RESEARCH REACTOR CENTER

REFERENCE: Docket 50-186
University of Missouri – Columbia Research Reactor
Amended Facility License R-103

SUBJECT: Written communication as specified by 10 CFR 50.4(b)(1) regarding responses to the “University of Missouri at Columbia – Request for Additional Information Re: License Renewal, Safety Analysis Report, Complex Questions (TAC No. MD3034),” dated May 6, 2010, and the “University of Missouri at Columbia – Request for Additional Information Re: License Renewal, Safety Analysis Report, 45-Day Response Questions (TAC No. MD3034),” dated June 1, 2010

Figure 1 – Temperatures and Heat Fluxes for Fresh Fuel

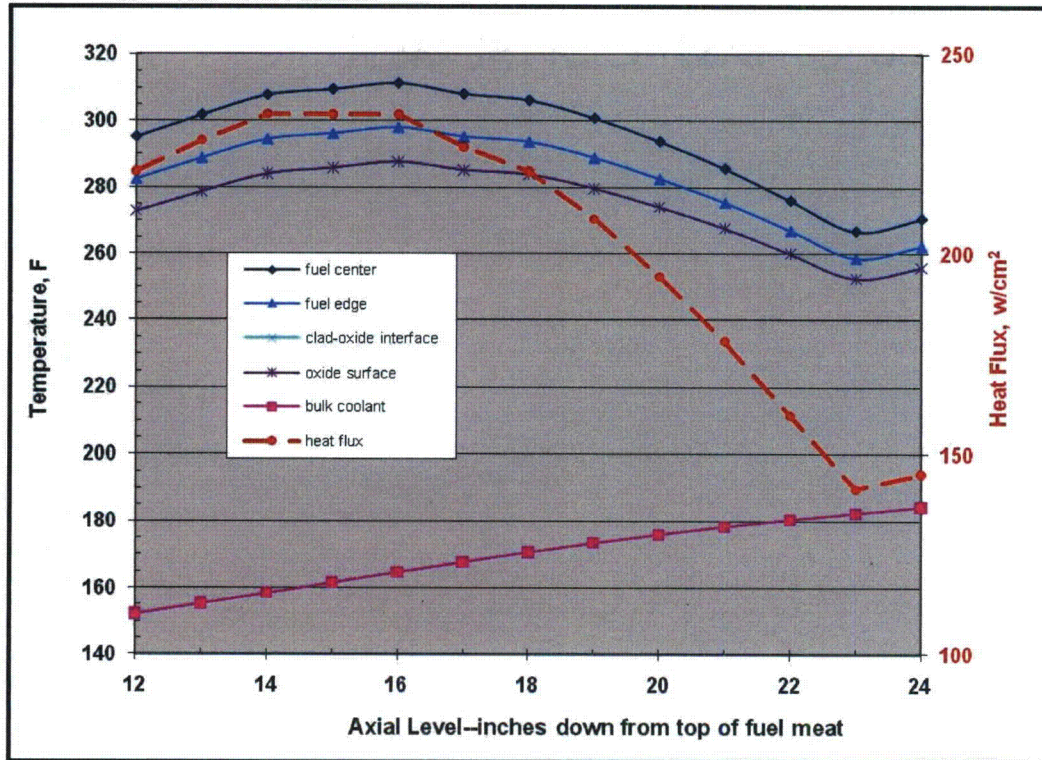
4.15 Section 4.6, Thermal Hydraulic Design, Page 4-43.

It is unclear what the thermal design limit and the operating limit are. Provide further clarification for the temperature limit of the fuel cladding. Discuss the effect of fuel oxide layer build-up on the results of the analyses.

Figures 1 and 2 provide the axial distributions of bulk coolant temperature and fuel plate surface heat flux for levels 12 through 24 (the exit) of the limiting fresh and high-burnup elements, respectively. The highest heat flux in the fresh fuel case occurred at axial level 14, where the heat flux of the higher power of the two plates bounding the channel was 4.116 times the core average heat flux. The axial level with the highest fuel meat temperature was found to be level 16. The heat fluxes at levels 15 and 16 of this plate are each 4.114 times the core average. The bulk coolant temperature rises 19.7 °F from level 16, where the peak fuel temperature occurs, to the exit. However, because this is more than offset by the effect of the decrease in heat flux over this

Figures 1 and 2 provide the axial distributions of bulk coolant, oxide surface, clad-oxide interface, fuel edge and fuel center temperatures of the levels 12 through 24 (the exit) of the limiting fresh and high-burnup elements, respectively. In Figure 1 the oxide surface temperature and clad-oxide interface temperature are coincident since the oxide layer, in effect, has a thickness of 0.0 inches. The red dashed curve in each of these figures provides the heat flux distribution, which is indicated in W/cm² along the right axis. As these figures and the bold red values in Table 3 show, the peak fuel temperatures for the fresh and high burnup fuel are 311.3 and 303.6 °F, respectively.

As Table 3 shows, at the limiting axial level the temperature rise from the bulk coolant to the fuel plate centerline is 311.3 – 164.7, or 146.6 °F for the fresh fuel case and 303.6 – 163.7, or 139.9 °F for the high-burnup case. In both instances the clad and fuel meat temperature rises are relatively small and most of the temperature rise is due to the film temperature rise, the temperature rise from the bulk coolant to the surface of the oxide layer or the surface of the fuel plate when there is no oxide layer. For the high-burnup case the oxide temperature rise is 38.7 °F. This value would need to increase by 7.7 °F, or 20%, for the peak fuel temperature of the high-burnup case to achieve the peak fuel temperature of fresh fuel case. Thus, the high-burnup fuel with its oxide layer has lower peak fuel temperatures than does the oxide-layer-free fresh fuel. Also, the blister temperature for aluminide fuel is over 900 °F (482 °C).

In conclusion, the predicted peak fuel temperature is 311.3 °F. It occurs in the fresh fuel rather than in the high-burnup fuel and is far from the cladding blister temperature.
